Early Site Permit (ESP) Application for the Clinton ESP Site
Docket No. 52-007

Subject: Responses to Supplemental Draft Safety Evaluation Report (DSER) Items

Re: Letter, U.S. Nuclear Regulatory Commission (W. D. Beckner) to Exelon Generation Company, LLC, (M. Kray), dated August 26, 2005, Supplemental Draft Safety Evaluation Report for the Exelon Early Site Permit Application

Figure 2.5.1-1-1: Comparison of mean repeat time distributions computed assuming a Poisson model for prehistoric earthquake dates developed from data in the three sections of the New Madrid seismic zone

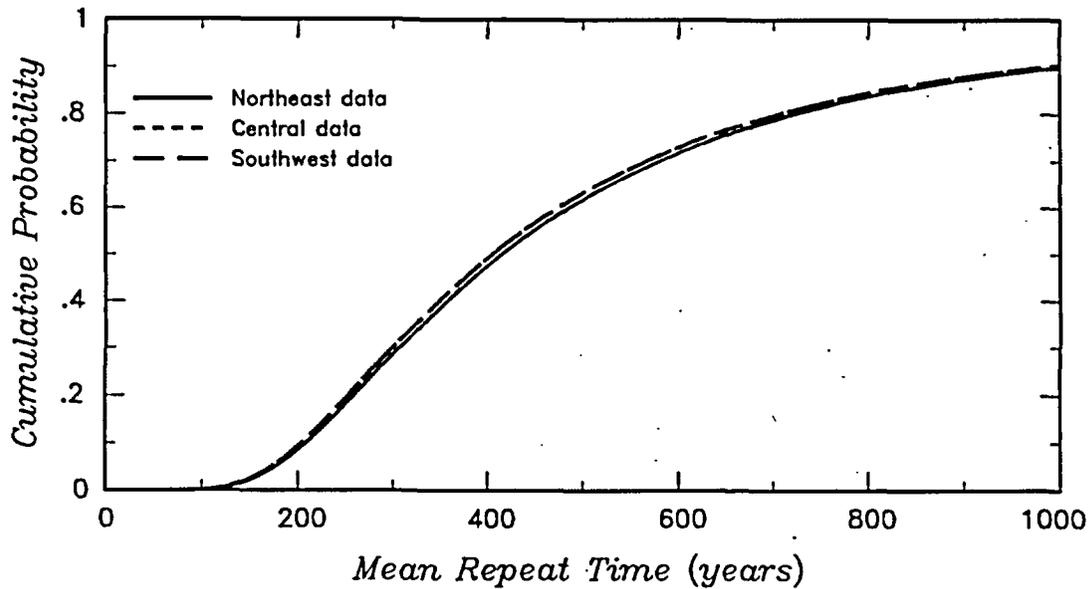
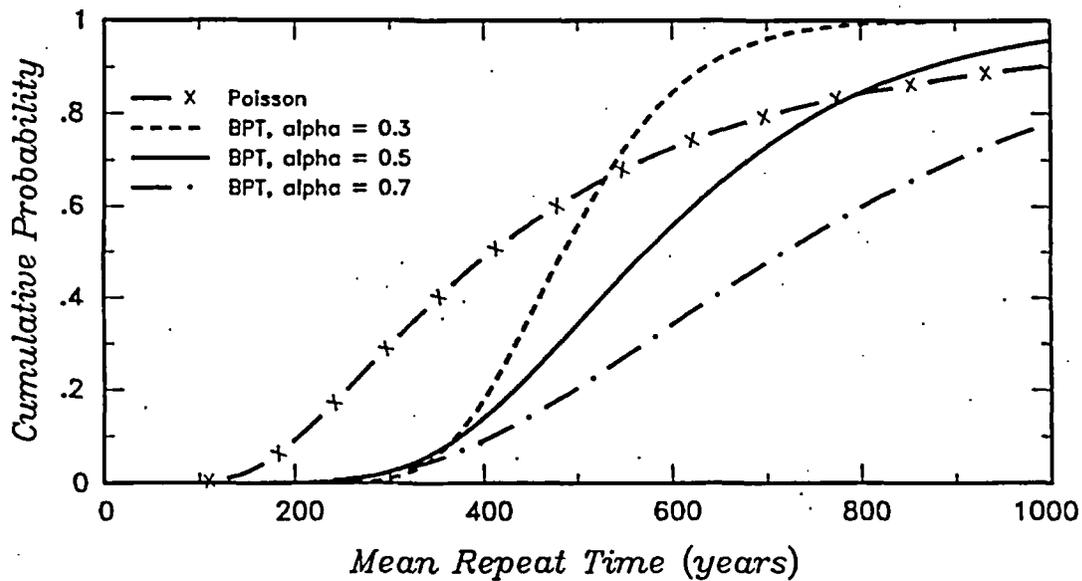
DSER Open Item 2.5.1-1

The calculation of the occurrence times presented in the response to RAI 2.5.2-5 were based on the estimated dates for previous New Madrid earthquakes derived from radio-carbon dating of paleoliquifaction features in the north-east portion of the New Madrid seismic zone in the vicinity of the New Madrid North fault (Attachment 2 to Appendix B of the FSAR). These analyses were repeated using data from the central and southwestern portions of the New Madrid seismic zone. All three sets of data produce essentially the same estimates of mean return period. Figure 2.5.1-1-1 shows the uncertainty distributions for mean repeat time derived from the three data sets assuming a Poisson recurrence model. The updated occurrence rates of equivalent annual frequency of New Madrid earthquake sequences were computed by combining the estimated dates for prehistoric earthquakes from all three sections of the seismic zone. Figure 2.5.1-1-2 shows the resulting distributions for mean repeat time derived using the Poisson and BPT models. Table 2.5.1-1-2 lists the resulting distributions for equivalent annual frequency of New Madrid clusters.

- 3) Revision of SSAR, Appendix B, Section 4.1, Figures 4.1-1, 4.1-3, 4.1-9 thru 4.1-16, 4.1-19 thru 4.1-21. For example, SSAR Appendix B, Figure 4.1-1 will be updated with the information in the open item response Figure 2.5.1-1-3, and SSAR Appendix B, Figure 4.1-3 will be updated with the information in the open item response Table 2.5.1-1-2, and Figures 2.5.1-1-1 and 2.5.1-1-2.

Figure 2.5.2-1-1: Fit of Equation (1) to Atkinson and Boore (1995) simulated ground motion data for hard rock conditions

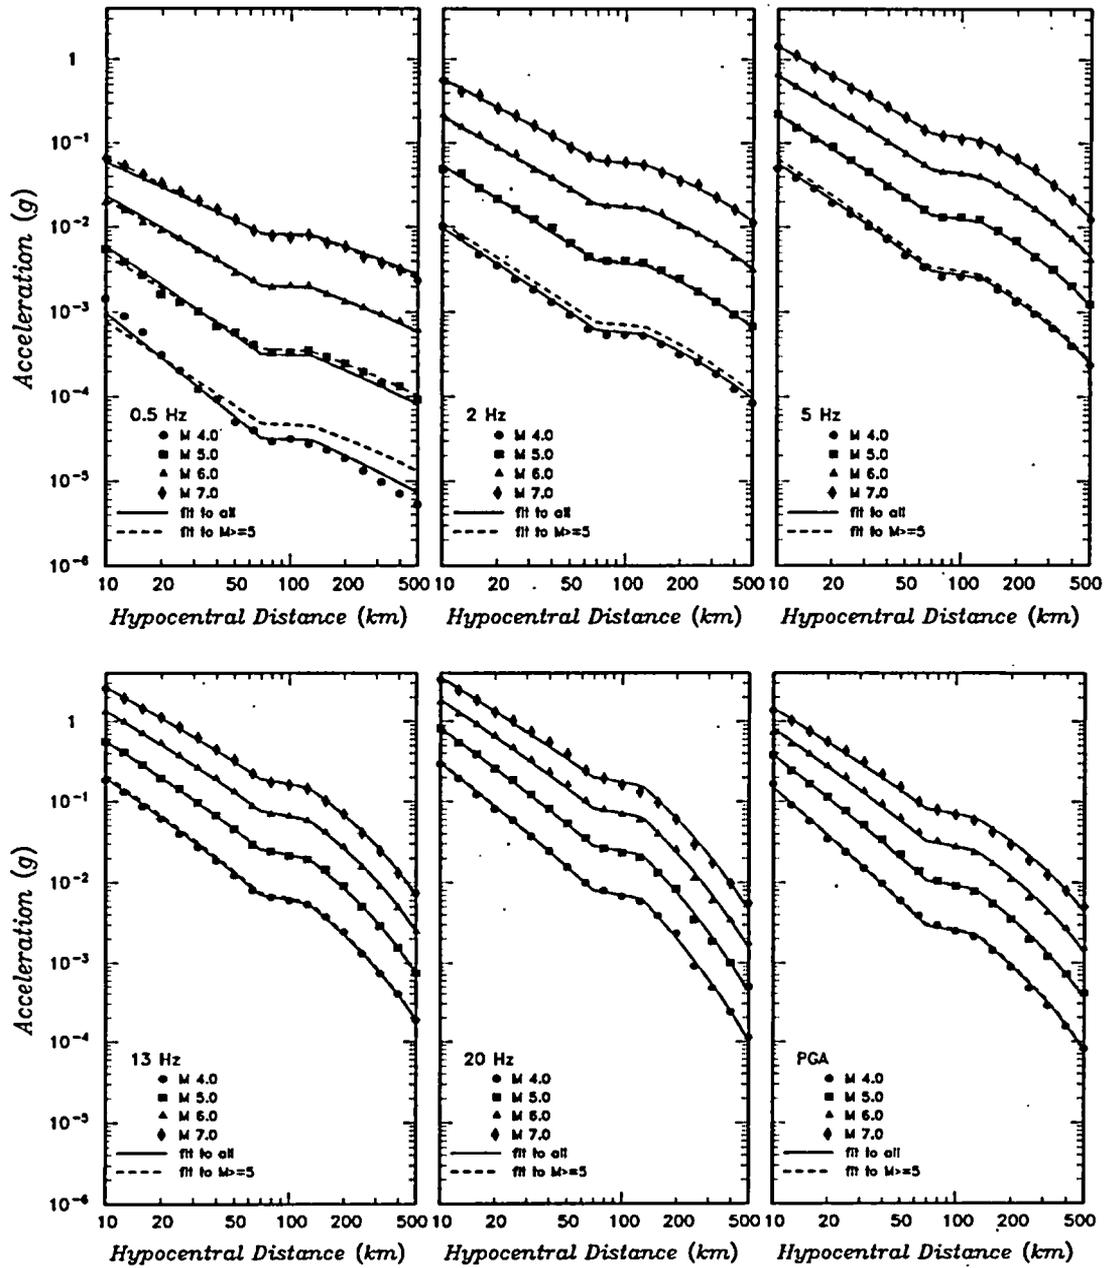
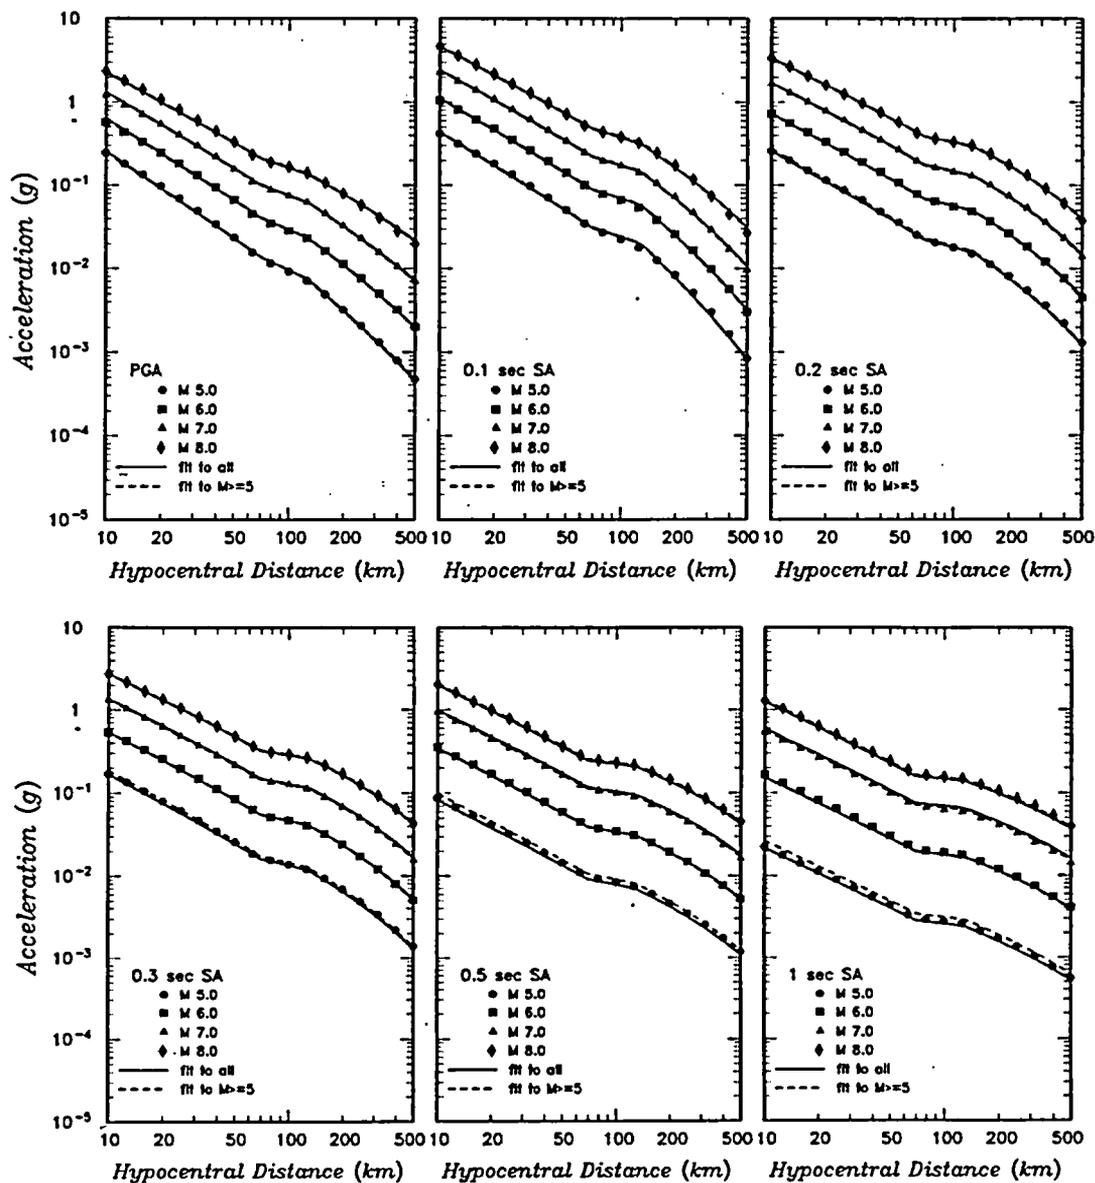
DSER Open Item 2.5.2-1

The Atkinson and Boore (1995) and Frankel et al. (1996) ground motion models are defined in terms of tables of median ground motion values for a range of magnitudes and hypocentral distances. EPRI (2004) developed functional forms to represent these models in their analysis. The first step was to fit a functional form to the tabular data. Figures 2.5.2-1-1 and 2.5.2-1-2 show the tabulated data and the resulting fits using the functional form

for Atkinson and Boore (1995) data (Figure 2.5.2-1-1) and

for Frankel et al. (1996) data (Figure 2.5.2-1-2) where m is moment magnitude and r is equivalent point-source distance. These forms were chosen to match the characteristics of the ground motion simulation models used in developing the tabular data, in particular the form of distance attenuation. For ease in comparing these two relationships with the other models within their respective clusters, the "hypocentral" distance versions were converted into r_{JB} version by the following process. A synthetic data set was created by simulating data for a specific set of r_{JB} values using a distribution of equivalent point source depths. The point source depth distributions developed by Silva et al. (2002) were used in generating the synthetic data. These point source depth distributions were developed from the hypocentral depth distributions published by EPRI (1993) accounting for adjustments from hypocentral to asperity depth as a function of earthquake magnitude. Table 2.5.2-1-1 gives the parameters of these distributions. For comparison, EPRI-SOG (1988) used a fixed depth of 10 km in applying the stochastic point source ground motion models and Frankel et al (1996) used a fixed depth of 5 km with a minimum hypocentral depth of 10 km. Figure 2.5.2-1-3 shows examples of the simulated data for the Frankel et al. (1996) ground motion model. The simulated data were then fit by modified versions of Equations (1) and (2) to add a "fictitious depth" term to convert r_{JB} into equivalent point source distance. The modified functional forms are:
